Title: MTO2017 Thermostat Oil temperature Sensor Re-positioning		
AG-SB-2021-04-B-EN	Effective Date: 16 June 2021	Compliance Category: A – MANDATORY B – RECOMMENDED C – OPTIONAL
Applicability		
Aircraft type & model: AutoGyro MTO2017	Affected Serial number(s): AutoGyro MTO2017 912/914 fitted with an oil thermostat II incorporating an oil temperature sensor	
The maintenance manual to be referenced is this stated or subsequent issue.		As per AutoGyro website
<p>This form is the response from AutoGyro GmbH either against a problem found in the product in service requiring a containment or rectification action, or as service information for aircraft modification incorporation. For help, contact AutoGyro on 49(0)5121 88056-00, or email airworthiness@auto-gyro.com.</p>

Reason and overview of the Service Bulletin

This document gives instructions on the re-positioning of the oil temperature sensor.

Pic. 1

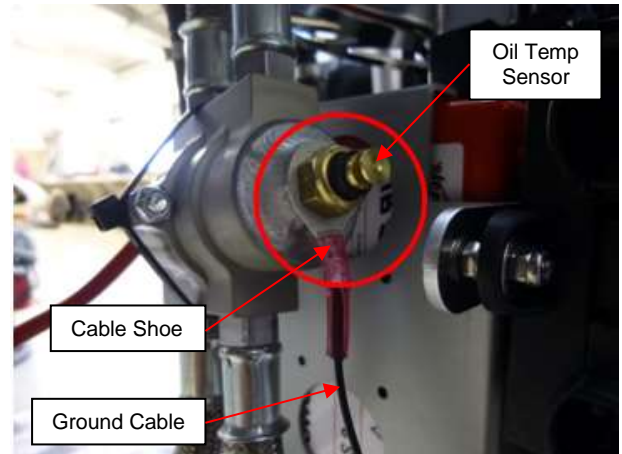
1. Remove the sensor cable from the sensor (Pic. 1) and carefully remove the oil temperature sensor from the old thermostat assembly housing. Heat may be required to release the Loctite bond. Clean/degrease threads using Loctite 7063 (Pic. 2).
2. Cut the cable shoe from the end of the ground cable, protect with heat-shrink and secure suitably (Pic. 2).

Pic. 3

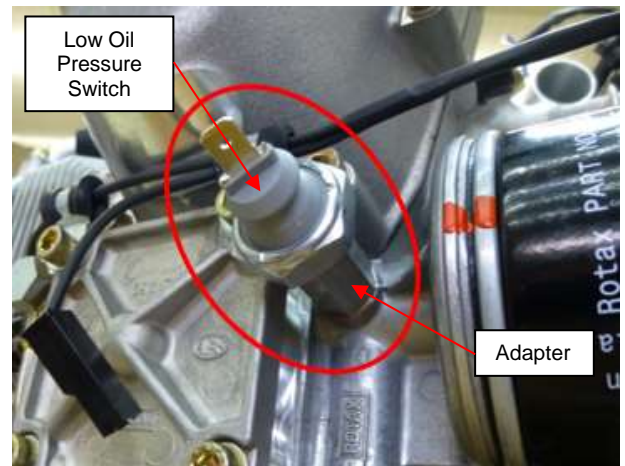
3. Connect the oil temperature sensor cable extension (Pic. 3) to the existing cable and suitably re-route to run across the top of the engine to the rear right side of the engine (the current position of the low oil pressure LED sensor, Pic. 4). Ensure the cable connection is insulated with heat shrink or similar once connected.

4. Remove the low oil pressure LED switch & adapter from the engine (Pic. 4).
5. Remove the switch from the adapter. Clean the threads of the sensor and the (now open) engine mounting position with Loctite 7063. Assemble the switch into the new adapter (Pic. 3) using 1 x copper washer (Pic. 3). NOTE: The adapter has been modified – the item in Pic. 3 is correct, the item in Pic. 10 is the older version.

Pic. 5

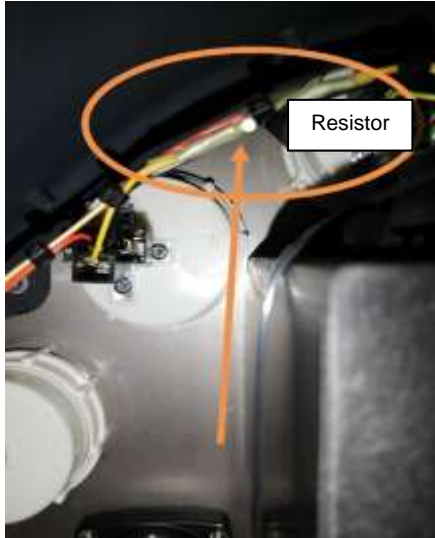
6. Apply Loctite 542 thread sealant to the threads of the temperature sensor and assemble to the engine (Pic. 5).
7. Connect the temperature sensor cable to the temperature sensor (Pic.6).

Pic. 7

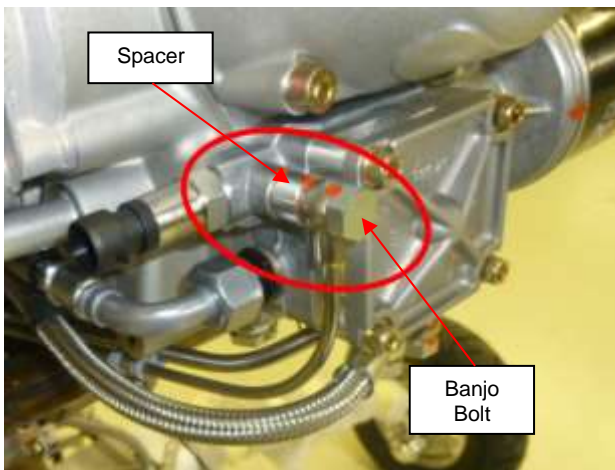
8. It may be the case that the oil temperature gauge has a resistor installed. This can be verified by gaining access to the rear of the instrument and observing if an additional item in the signal wire between instrument and wire is visible (Pic. 7). If this is found to be present, the resistor should be removed and the wire re-joined with a suitable in-line connector.

Pic. 9

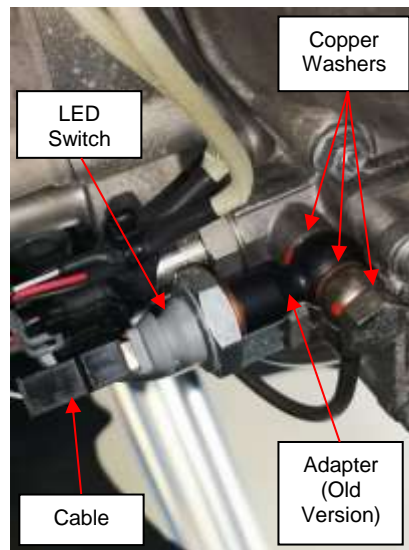
12. Remove the banjo bolt securing the turbo oil line to the oil pump housing (Pic. 9). This item is re-used for the assembly of the low pressure switch.
13. Remove the spacer between housing and oil line (Pic. 9). Clean the internal threads of the housing and banjo bolt using Loctite 7063.
14. Apply Loctite 542 thread sealant to the threads of the original banjo bolt and assemble the pressure switch/adaptor assembly, banjo bolt, oil line and 3 x copper washers (Pic. 10) to the engine. Ensure new copper washers are assembled either side of the adapter and oil line (Pic. 10).
15. Connect the low pressure LED switch extension cable (Pic. 3) to the existing pressure switch cable and suitably re-route between the propeller gearbox and oil pump housings to the new sensor position. Connect to the sensor.
